# Access Compliance Report

## Public Rights-of-Way

### (Pedestrian Signals)

| ADA ID: 93E48D3A2748                    | Signal Type: One Push Button-APS | Overall Compliance: No                  | Severity Score: BTN 1: N/A BTN 2: N/A No BTN: N/A |

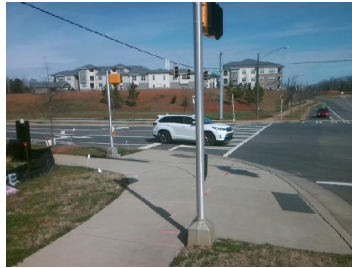
PROW/ADA: TMUTCD 4e.08, R404.2, R404.3, R406.2, R209.1, MUTCD 4e.10

| Compliance | Description                             | Data    | Compliance | Description                            | Data         |
|------------|-----------------------------------------|---------|------------|----------------------------------------|--------------|
| No         | B 1 Clear Floor Space Slope (%)         | 4.2     | N/A        | B 2 Clear Floor Space Slope (%)        | N/A          |
| No         | B 1 Clear Floor Space XSlope (%)        | 4.9     | N/A        | B 2 Clear Floor Space XSlope (%)       | N/A          |

| No B 1 DistanceTo Curb (in)   | 83.0          | N/A | B 2 DistanceTo Curb (in)  | N/A |

Possible Solutions: Replace Signal Push Button With APS Button on New Post. Remove & Relocate Sign.
